MEMORANDUM

Re: **Montgomery 206 Realty (Dunkin')**
Conditional Use + Amended Preliminary and Final Site Plan
Route 206 & Route 518
Block 28005, Lot 64
HC Highway Commercial District

Date: August 13, 2021, last revised September 23, 2021

RE: Montgomery 206 Realty – Dunkin'
Amended Preliminary and Final Site Plan
Application #BA-04-21
Engineering Review #2
Block 28005, Lot 4
1276 US Highway 206
Township of Montgomery, Somerset County

Plantings & Buffer Changes

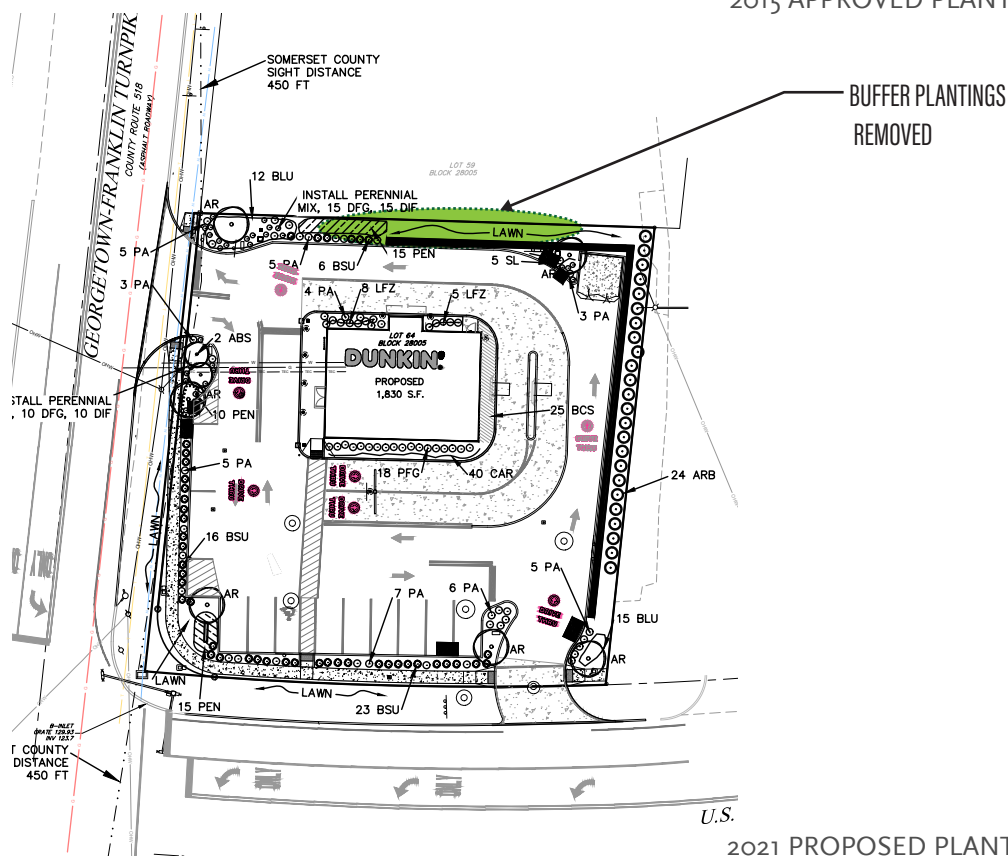
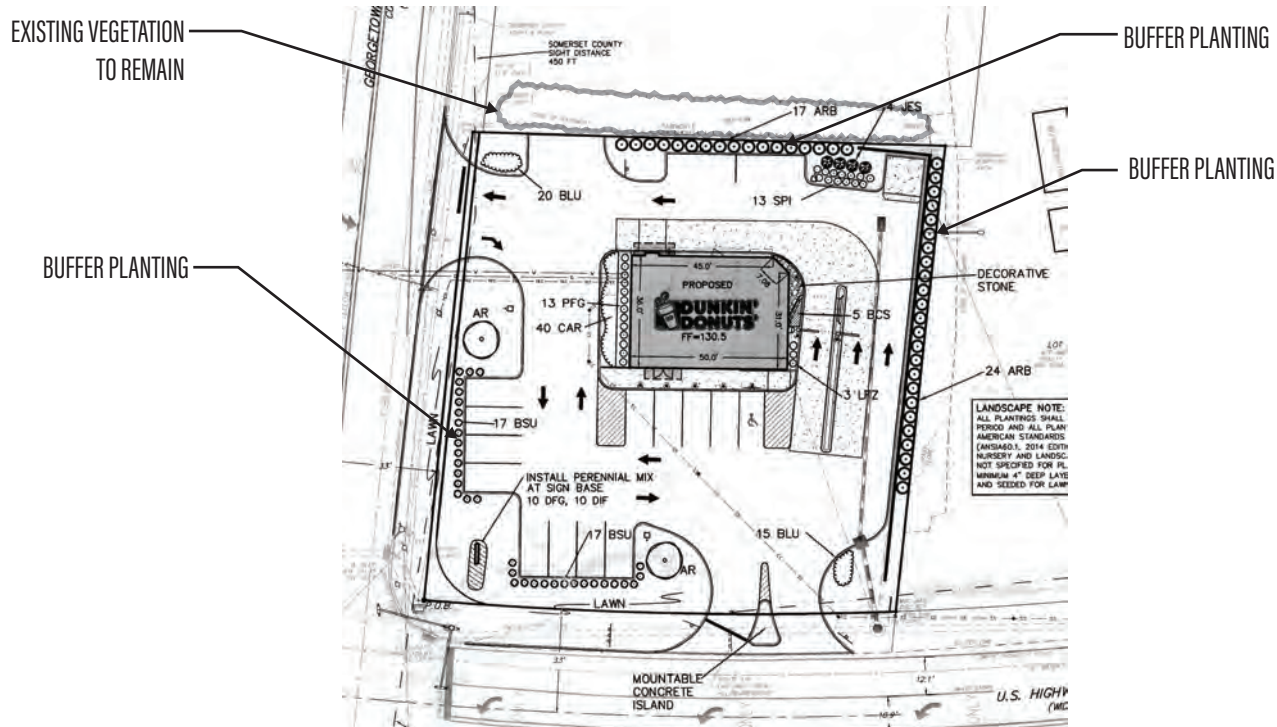
While screening is proposed along the site's boundaries, the drive-through window, signage and driveway will be visible from adjacent properties. The Board previously granted variance relief for this standard; however, the Landscape Plan has changed since the prior approval.

The applicant has removed the approved buffer planting along the western lot line and the southern lot line. Despite shifting the retaining wall 6-feet from the property line, the applicant is proposing lawn instead of plantings along the outer side of the wall. The applicant should provide testimony as to why lawn is proposed instead of plantings. Moreover, the applicant has removed the potential future connection to the property to the west, and instead, has identified has added some golden ragwort, green velvet boxwood and Hamelin dwarf fountain grass. The applicant is continuing to propose a small planting bed adjacent to the trash enclosure and has added a row of golden ragwort and green velvet boxwood along the Route 518 frontage. While the applicant is not proposing to maintain the existing vegetation on the neighboring property to the west, they are not proposing plantings along the majority of the westerly lot line to adequately screen the drive through window.

Some additional plantings adjacent to the ingress drive from Route 518 have been added, but these are not sufficient to satisfy this standard. *The Board should examine these changes and their impacts in order to consider whether relief should be granted from this standard.*
